Technical Service Bulletin

Mazda North American Operations
Irvine, CA 92618-2922

Subject: FRONT DOOR INTERFERES WITH REAR DOOR GARNISH (MAZDA3 5-DOOR HATCHBACK)	Bulletin No.: 09-033/23
	Last Issued : 09/26/2023

Old	New
Clip		
Hole at the door sheet metal panel

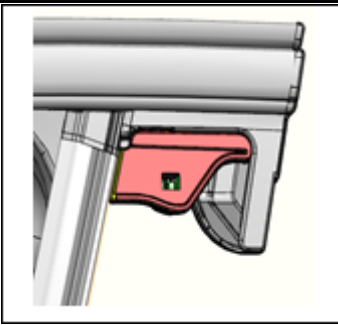
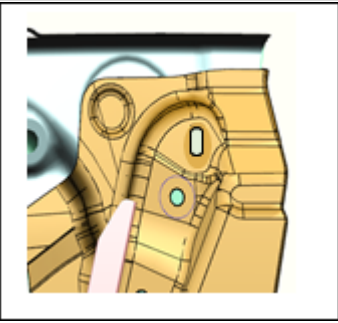
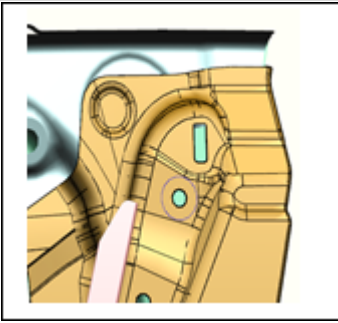
Since the front door glass run channel is not fixed to the door strongly enough for the following situations, cycles of door operation may result in interference and lead to damage on the seal rubber at the rear door.

- When the front door glass is closed, the glass run channel may be forced to move to the B pillar side.
- In very hot climates, the glass run channel may expand to the B pillar side.

To eliminate this concern, the following 2 phases have been started as a running change:

- Phase 1
 - Adhesive has been added between the front door glass run channel and the door panel.
- Phase 2
 - The shape of the front door glass run channel has been changed so as not to make contact with the rear garnish.
 - The shape of the clip at the rear side of the front door glass run channel has been changed for stronger fixing and the hole at the **door sheet metal panel** has been changed accordingly.

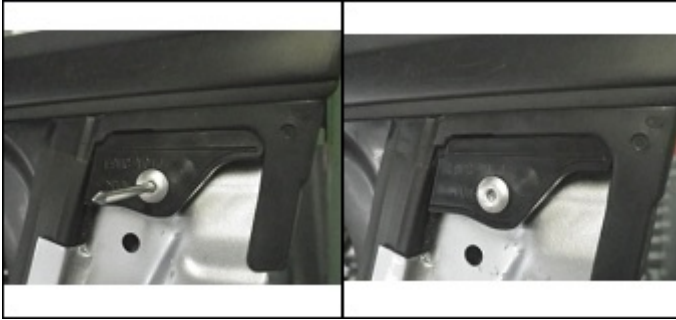
c. Cut the clip off which does not fit with the hole at the **door sheet metal panel**.

d. Reassemble the clip plate and install the modified front door glass run-channel to the **door sheet metal panel**

Front door glass run channel and sail garnish are integrally formed

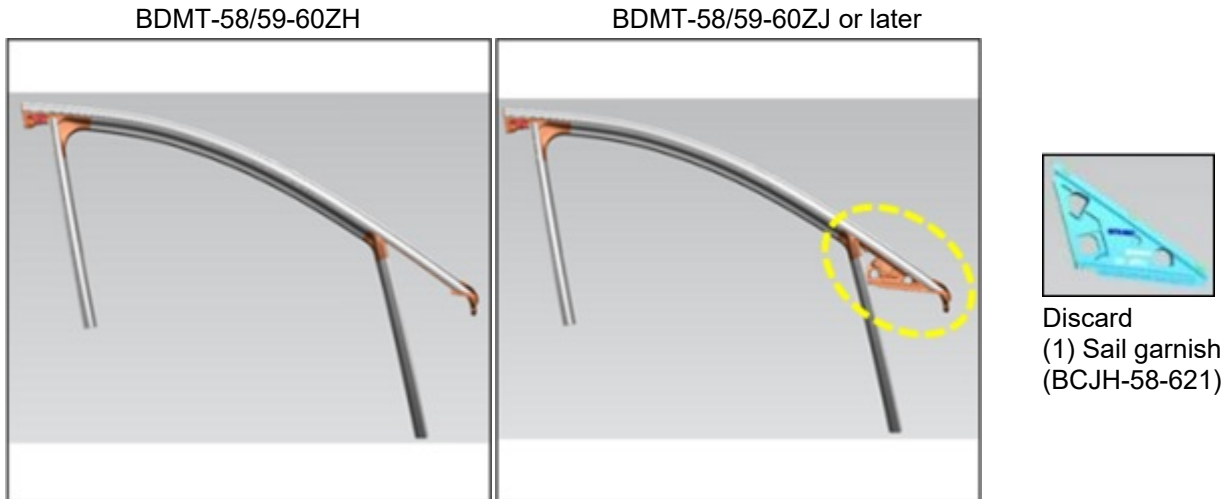
ATTENTION: There are two types of front door glass run channel.

- If the front door glass run channel obtained is BDMT-58/59-60ZJ or later level, remove and discard the sail garnish (1), which is originally installed on the vehicle according to the instructions on MGSS (SAIL GARNISH REMOVAL/INSTALLATION), before installing the front door glass run channel.
